METHODOLOGY ASSESSMENT REPORT ASSESSMENT REPORT ON METHODOLOGY FOR BIOCHAR UTILIZATION IN SOIL AND NON-SOIL APPLICATIONS

Document Prepared by TÜV NORD CERT GmbH

Methodology Title	Methodology for biochar utilization in soil and non-soil applications
Version	1.1
Methodology Category	Methodology
Sectoral Scope(s)	13 – Waste Handling and Disposal
Report Title	Assessment report on Methodology for biochar utilization in soil and non-soil applications
Report Version	1.0
Client	VERRA
Pages	170
Date of Issue	04/08/2022

Figure 1: Project boundaries

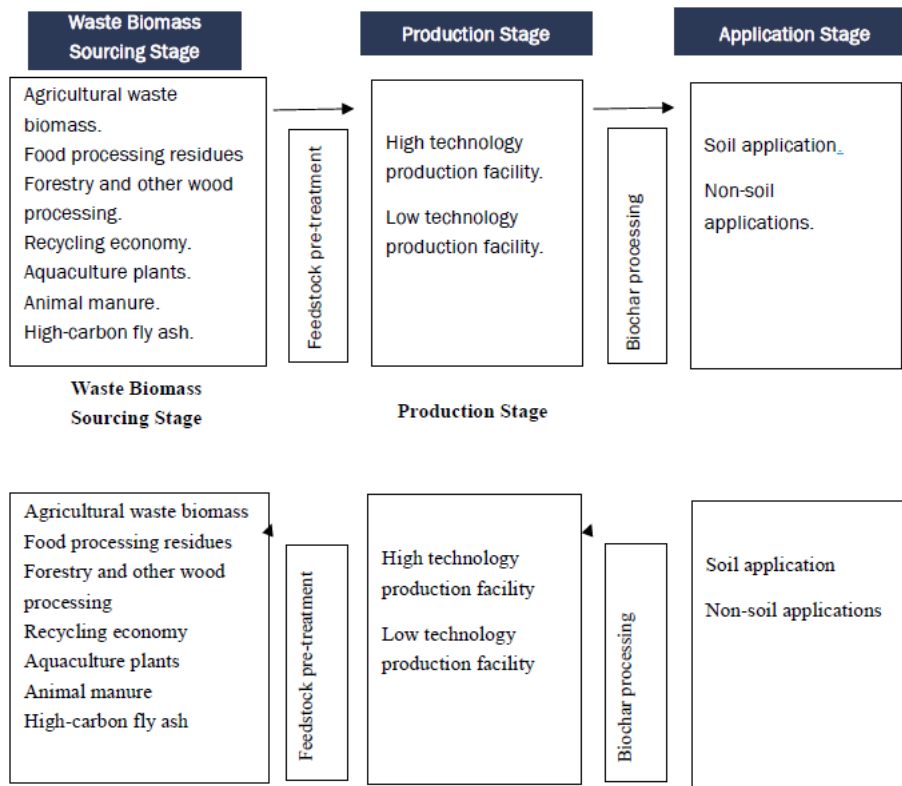
CL ID	06	Section no.	5	Date: 22/11/2021
Description of CL				
Please clarify the following issues w.r.t. Figure 1 in section 5:				
<ol style="list-style-type: none"> 1. Under waste biomass sourcing no reference is made to Food and HCFA. Pls clarify 2. Under application, it is referred to soil application and materials. Pls clarify why no reference to “non-soil” applications is made in line with other sections. 				
Project participant response				Date: 16/02/2022
<ol style="list-style-type: none"> 1. Figure 1 has been modified. Food and HCFA was included under sourcing stage 2. Non-soil application was included under application stage. 				
Documentation provided by project participant				
Revised methodology ver 1 dated 16/02/2022				
DOE assessment				Date: 10/03/2022
<ol style="list-style-type: none"> 1. Ok. Figure 1 refers now also to HCFA. 2. Ok. Figure 1 now also refers to non-soil application at the final application stage. <p>As all outstanding issues have been resolved, this finding is closed.</p>

Figure 2. Illustration of a qualified biochar scenario for biomass co-gen energy facilities.

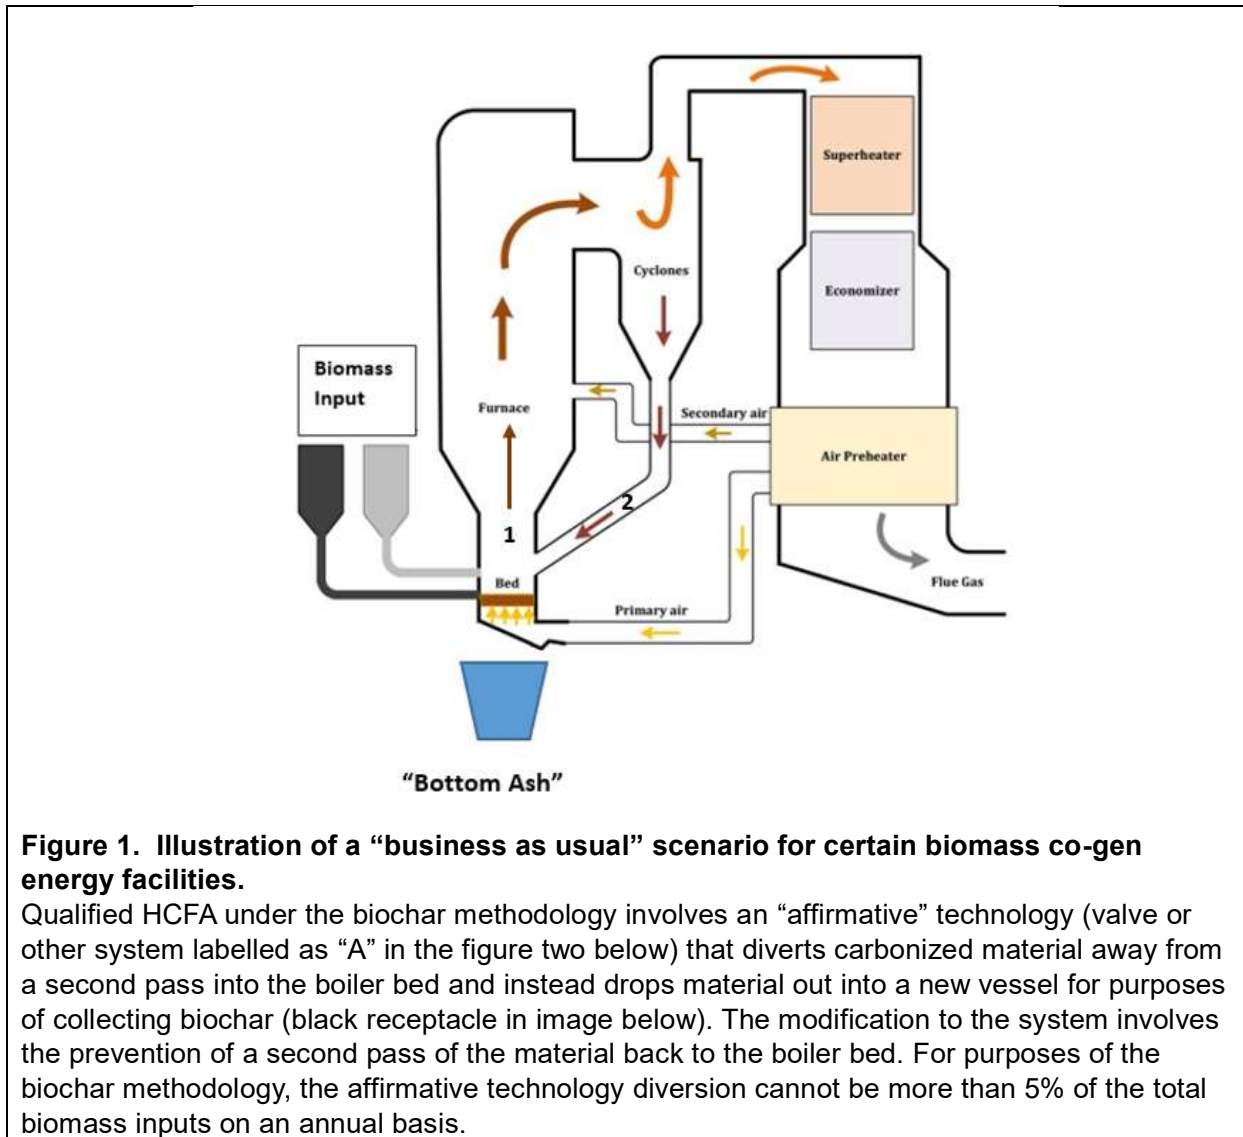
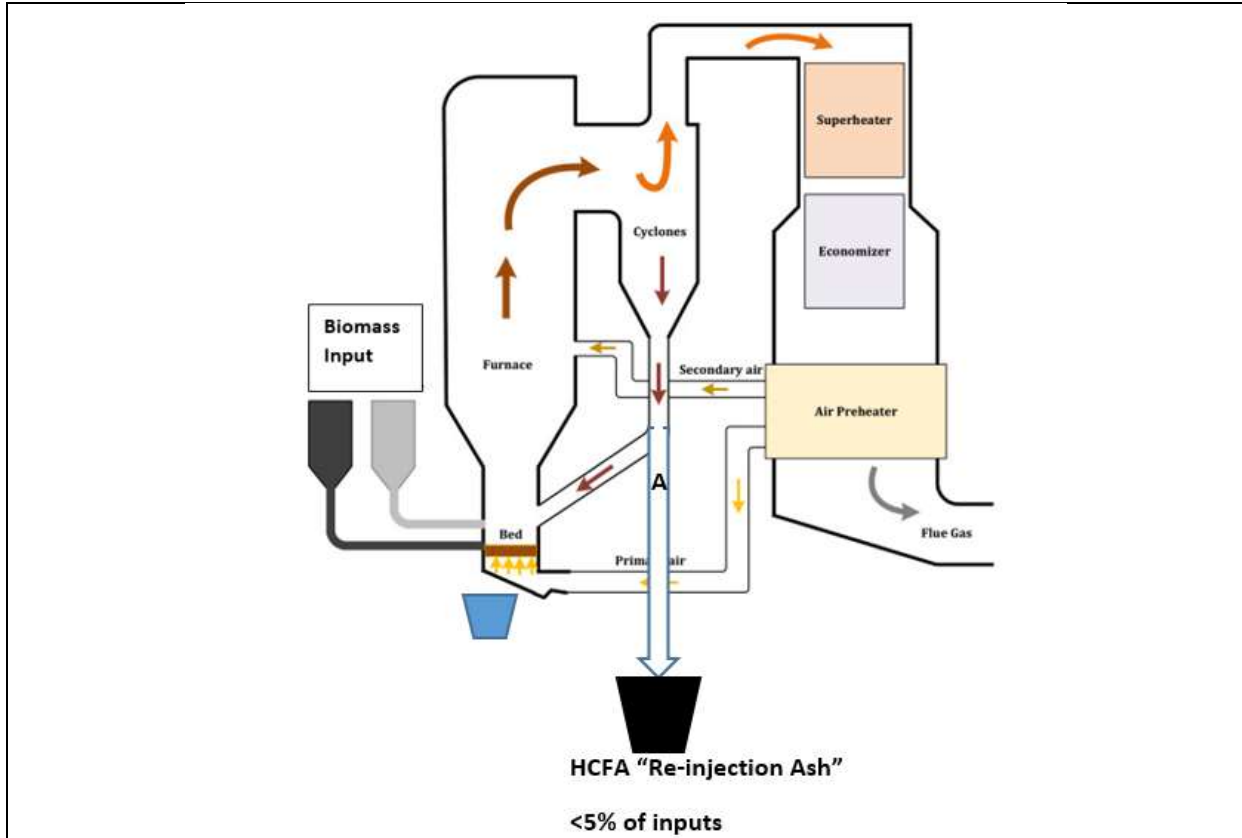
To illustrate the process, a figure adapted from You Lv et. al 2016 is used³⁸. Biomass enters from the left and drop onto the fluidized boiler bed (see #1 in Figure 1 below). It ignites and the combustion stream travels upwards. Some of the gases and biomass enter the multi-cyclones (in the center of the image below) and are **re-circulated** back to the biomass boiler bed (see #2 below). In this set up, biomass feedstocks are being combusted twice to extract the maximum caloric value from the material. Approximately 85% of the biomass is combusted on the first pass, and 13% to 14% is consumed on the second pass.
